# UNITED STATES PATENT AND TRADEMARK OFFICE

APPLICATION NO.	FILING DATE	FIRST NAMED INVENTOR	ATTORNEY DOCKET NO.	CONFIRMATION NO.
10/720,821	11/24/2003	Douglas B. Wilson	114089.120	5355
23483	7590	05/09/2006	EXAMINER	
WILMER CUTLER PICKERING HALE AND DORR LLP 60 STATE STREET BOSTON, MA 02109			LUONG, VINH	
			ART UNIT	PAPER NUMBER
			3682

<b>Office Action Summary</b>	<b>Application No.</b>	<b>Applicant(s)</b>
	10/720,821	WILSON, DOUGLAS B.
	Examiner Vinh T. Luong	Art Unit 3682

# ATTACHMENT 1

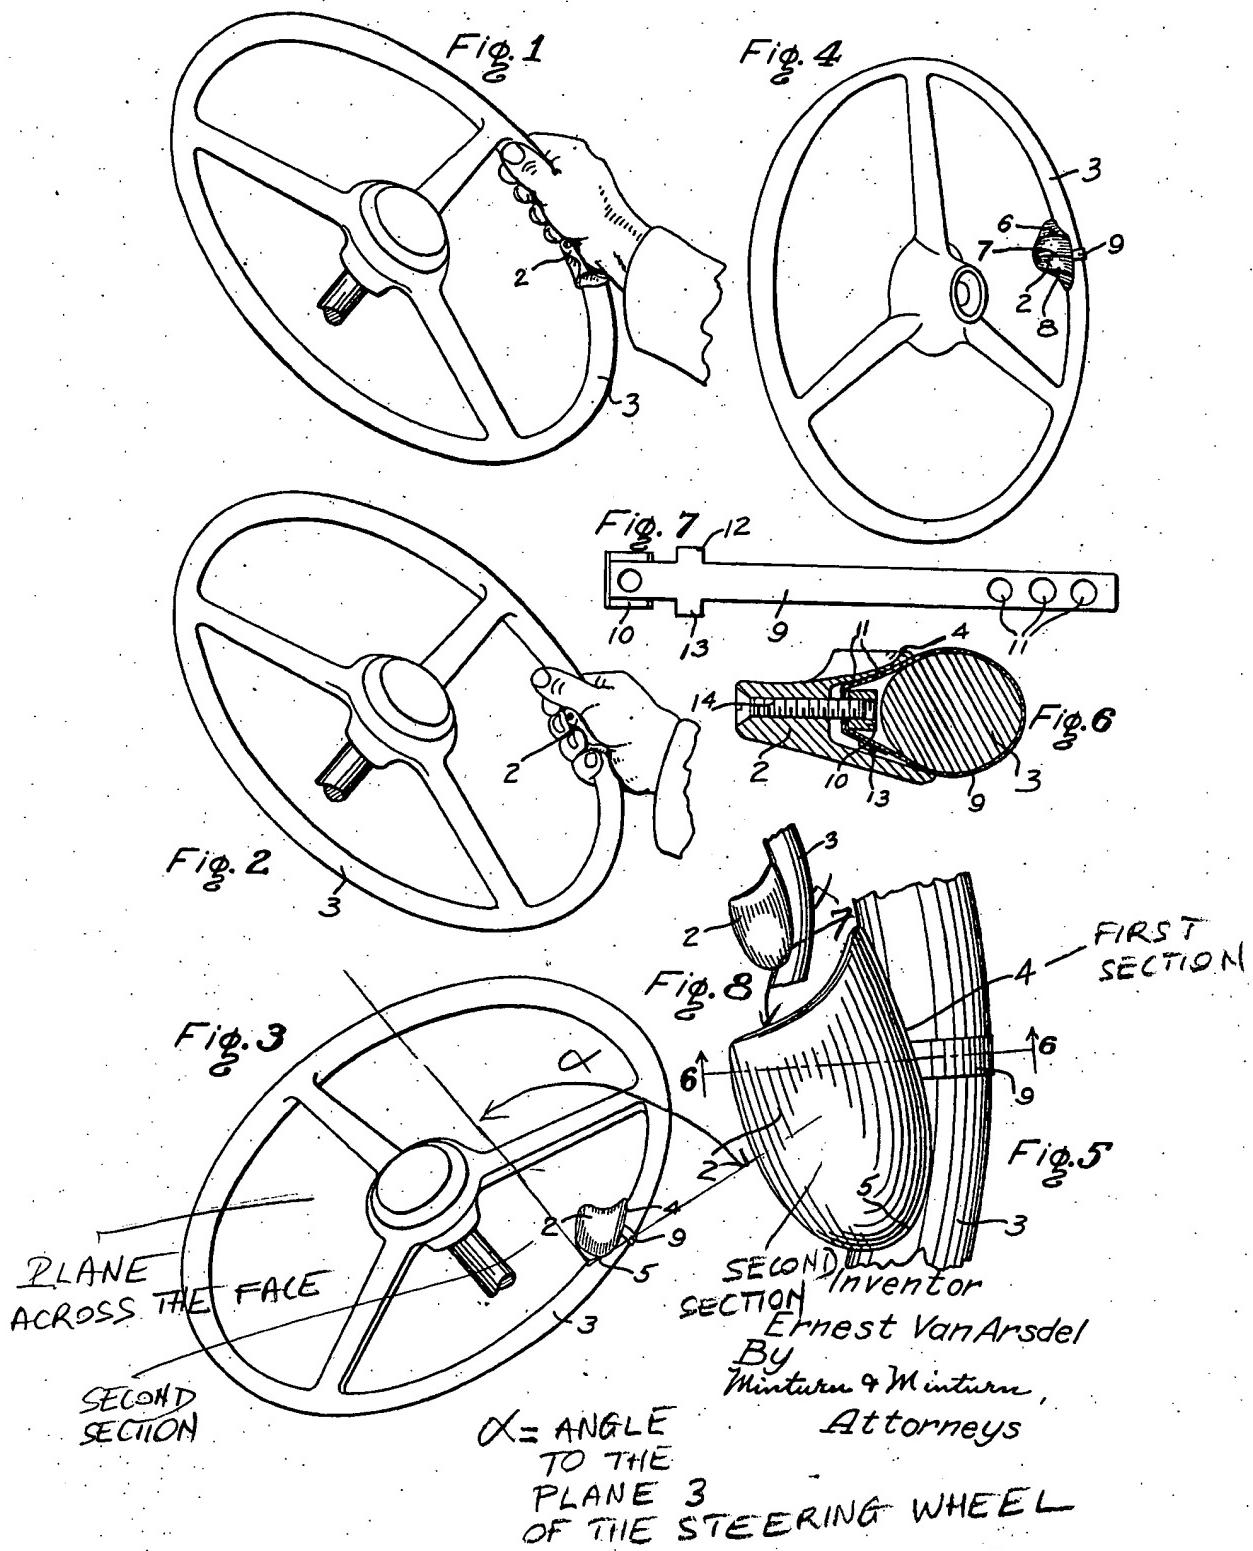
a second section 2 (*i.e.*, a concave upward section in Figs. 3 and 5) that connects to and extends from the first section 4 at the peripheral portion 3 of the steering wheel 3, the second section 2 extends from the first section 4 outward at an angle (see angle  $\alpha$  in Figs. 3 and 5 of the Attachment 1) to a plane (Att. 1) across a face to the steering wheel 3, with the second section 2 inherently for supporting at least a portion of a vehicular operator's body (e.g., the hand as seen in Figs. 1 and 2) when pressure from the portion of the vehicular operator's body on the second section 2 is less than the pressure for deforming the second section 2 out of interference with the vehicular operator's ability to operate the steering wheel 3, and deforming out of interference with the vehicular operator's ability to operate the steering wheel when pressure from the portion of the vehicular operator's body on the second section is equal to or greater than

steering wheel rim 3 in a manner to slope downwardly and inwardly of the rim. The outer edge 4 of the side, and 5 of the rear end of the *concave*, located above the rim, *extends up into a marginal flange* to be contacted by the inside of the ball of the thumb or by the bottom of the hand, depending upon which part of the hand is seated to rest.” See also Arsdel’s claims 1 and 2. Arsdel’s concave upward section 2 extends from the first section 4 outward at an angle  $\alpha$  to the plane across the face of the steering wheel as seen in Figs. 3 and 8 of Attachment 1. Therefore, Arsdel’s concave upward section 2 in Fig. 3 of Arsdel “reads on” Applicant’s claimed second section.

## **ATTACHMENT 2**

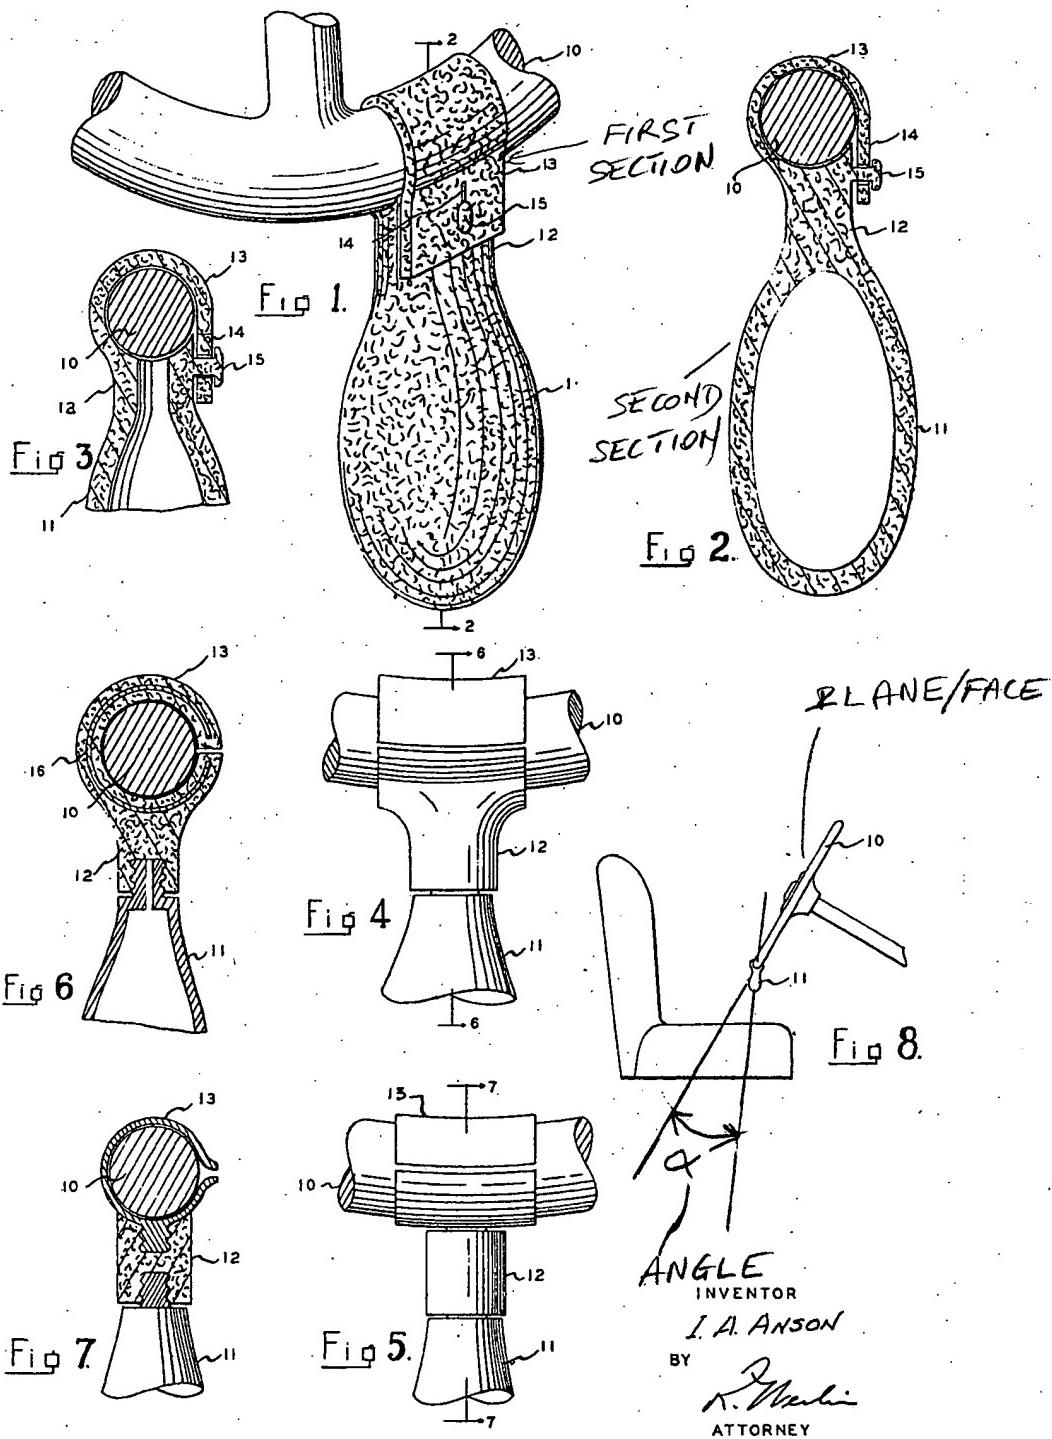
a first section 13 that connects to a peripheral portion of the steering wheel 10; a second section 11 extends from the first section at the peripheral portion of the steering wheel 10, the second section 11 extends from the first section 13 outward at an angle (see angle  $\alpha$  in Fig. 8 of Attachment 2) to a plane (Att. 2) across a face (Att. 2) to the steering wheel 3, the second section 11 inherently for supporting at least a portion of a vehicular operator's body (e.g., the hand) when pressure from the portion of the vehicular operator's body on the second section 11 is less than the pressure for deforming the second section 11 out of interference with the vehicular operator's ability to operate the steering wheel 10, and deforming out of interference with the vehicular operator's ability to operate the steering wheel 10 when pressure from the portion of the vehicular operator's body on the second section 11 is equal to or greater than the pressure for deforming the second section 11 out of interference with the vehicular operator's ability to operate the steering wheel 10.

# **ATTACHMENT 3**

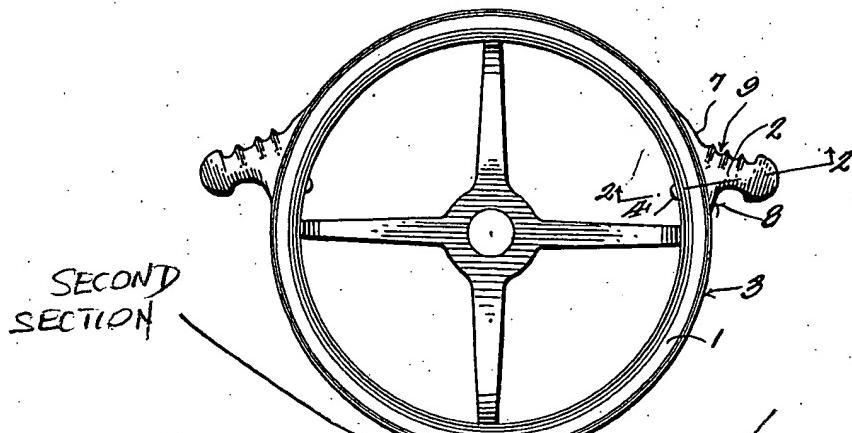
a first section 7, 8 that connects to a peripheral portion of the steering wheel 1;  
a second section 10 that connects to, and extends from, the first section 7, 8 at the peripheral portion of the steering wheel 1, the second section 10 extends from the first section 7, 8 outward at an angle (see angle  $\alpha$  in Fig. 2 of the Attachment 3) to a plane (Att. 3) across a face (Att. 3) to the steering wheel 1, the second section 10 inherently for supporting at least a portion of a vehicular operator's body (e.g., the hand) when pressure from the portion of the vehicular operator's body on the second section 10 is less than the pressure for deforming the second section 10 out of interference with the vehicular operator's ability to operate the steering wheel 1, and deforming out of interference with the vehicular operator's ability to operate the steering

Applicant further asserted that the Examiner’s drawings to attempt to show the enlarged head 10 is disposed outward at an angle from the plane across the face of the steering wheel is unsupported. Applicant’s instant assertion is in direct conflict with the substantial evidence presented in Laubach’s Fig. 2. This Fig. 2 shows that the second section of Laubach forms an angle with the face of the steering wheel as seen in Attachment 3. Note that things clearly shown
